SANTA ANA WATERSHED PROJECT AUTHORITY  
INLAND EMPIRE BRINE LINE REACH V  
REHABILITATION AND IMPROVEMENT PROJECT – PHASE 2

**ADDENDUM NO. 1**

INLAND EMPIRE BRINE LINE REACH V REHABILITATION & IMPROVEMENT PROJECT PHASE 2 DETAILS - 3
--

P:\101\Engineering\SAWPA\7616.0004 Reach V Rehabilitation Project\06.Design Data\CAD\Nichols Road\7616 SH10-12 D-1 to D-5 1/13/2016 10:57 AM

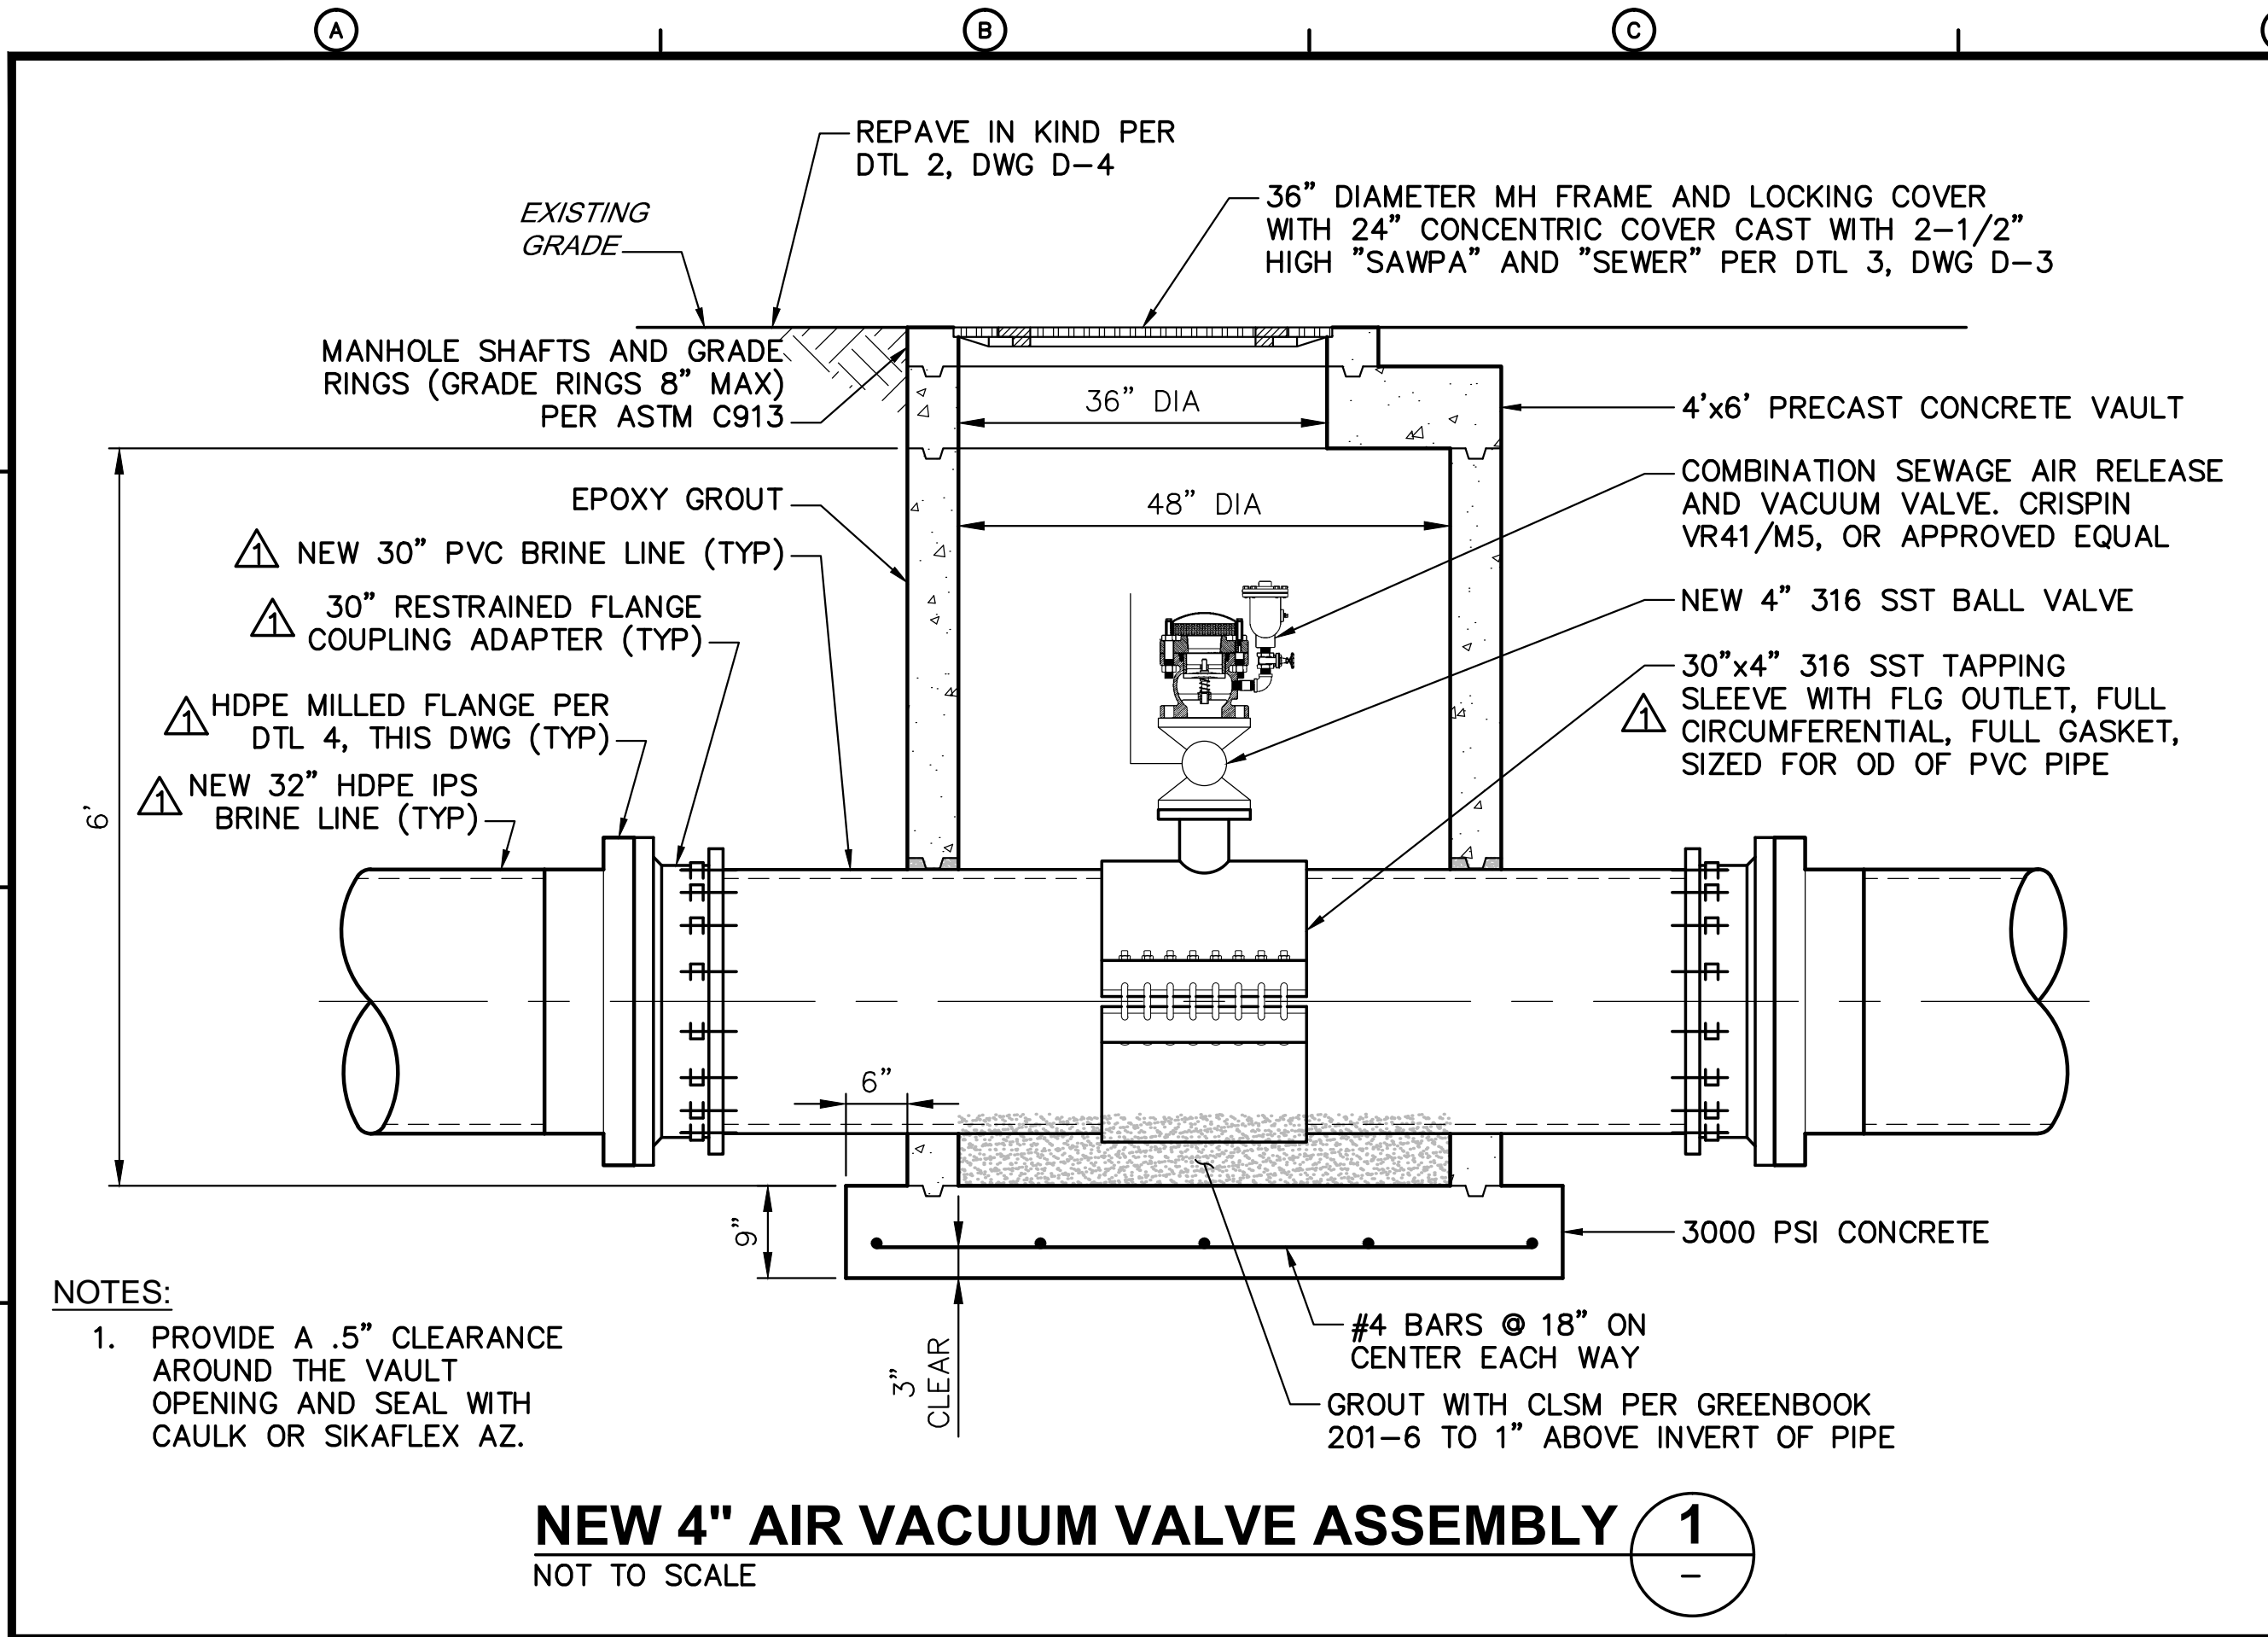
6. The following drawings shall be replaced with the attached revised drawings, indicating drawing revision 1 with a triangle.
  - a. Sheet D-3, in its entirety
7. Note 7 of Detail 1 on Sheet D-4 shall be changed to read: "Contractor shall furnish and install geotextile wrap (Mirafi 140N, or approved equal) around the pipe zone where the Contractor cannot obtain the required pipe zone compaction. Contractor shall coordinate with the Owner or his assigned representative to confirm the requirement for geotextile wrapping and install said geotextile as directed, at no additional cost to the Owner."

REV. NO.	DATE	DRWN	CHKD	CITY APPROVAL	DATE	REMARKS
1/13/16	CJD	DMM	-	-	-	ADDENDUM NO. 1: REVISED DTLs 1, 2, 4 & ADDED DIM SCHEDULE

HDPE FLANGE DIMENSIONS			
SIZE	OUTSIDE DIAMETER ("A")	BOLT CIRCLE ("B")	NO. OF BOLTS ("C")
24"	2'-8"	2'-5.5"	20
32"	3'-2.75"	3'-0"	28
